Access Compliance Report

Public Rights-of-Way

(Curb Ramps)

Intersection ID: 44465	Main Street: AINSWORTH_ST	Cross Street: VALCOURT_RD	Location: NE
ADA ID: C6DF15B1F28E	Ramp Type: PerpDiag	Initial Pass/Fail: Fail	Overall Compliance: No
Severity Score: 35			
Codes/Mitigation Info/Possible Solution		Field Measurements/Component Compliance

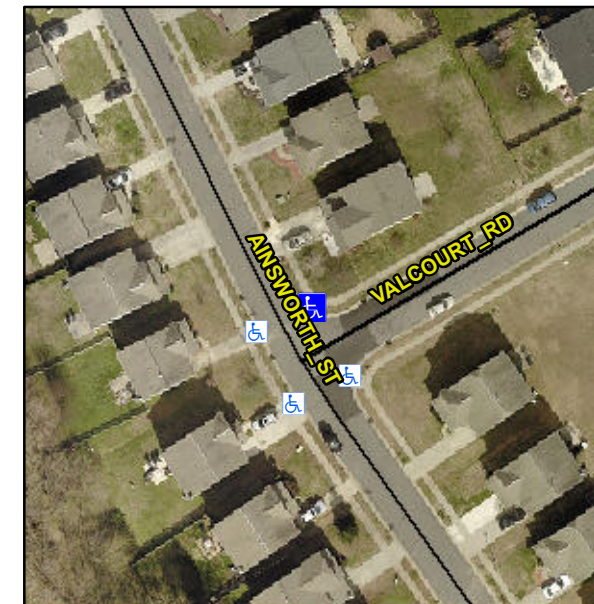
Compliance	Description	Data	Compliance	Description	Data
N/A	Ramp Length (in)	48.0	Yes	Ramp Slope (%)	7.7
No	Ramp Width (in)	31.0	Yes	Ramp XSlope (%)	1.5
N/A	Flare Type LT	N/A	N/A	Flare Type RT	N/A
N/A	Flare Slope LT (%)	N/A	N/A	Flare Slope RT (%)	N/A
N/A	Flare Traversable LT?	N/A	N/A	Flare Traversable RT?	N/A
N/A	Landing Length (in)	N/A	N/A	DWS Provided?	N/A
N/A	Landing Width (in)	N/A	N/A	DWS Contrast?	N/A
N/A	Landing Slope (%)	N/A	N/A	DWS Length (in)	N/A
N/A	Landing X Slope (%)	N/A	N/A	DWS Full Width?	N/A
N/A	Landing Curb? (Y/N)	N/A	N/A	DWS Offset (in)	N/A
N/A	Shared Landing?	N/A			
N/A	Gutter Ponding?	N/A	N/A	Gutter Slope (%)	N/A
N/A	Gutter Lip Ht (in)	N/A	N/A	Gutter X Slope (%)	N/A
N/A	Painted X Walk1?	No	N/A	Painted X Walk2?	No
	X Walk 1 Direction	To W		X Walk 2 Direction	To S
N/A	X Walk 1 Width (in)	N/A	N/A	X Walk 2 Width (in)	N/A
	X Walk 1 Slope (%)	1.2		X Walk 2 Slope (%)	3.8
	X Walk 1 X Slope (%)	2.2		X Walk 2 X Slope (%)	1.1

N/A	Ramp inside XWalk1?	N/A	N/A	Ramp inside XWalk2?	N/A
	Road Slope (%)	1.7	N/A	Clear Space?	N/A
	Road X Slope (%)	0.9	N/A	Clear Space to XWalk (in)	N/A
N/A	Any Obstructions?	N/A	N/A	Storm Grate/Utility Hazard?	N/A
	Obstruction Type			Storm Grate/Utility Type	
		N/A			N/A
			Yes	Surface Condition? (G/P)	Good

Remove & Replace Curb Ramp With Two New Directional Ramps or Equivalent.
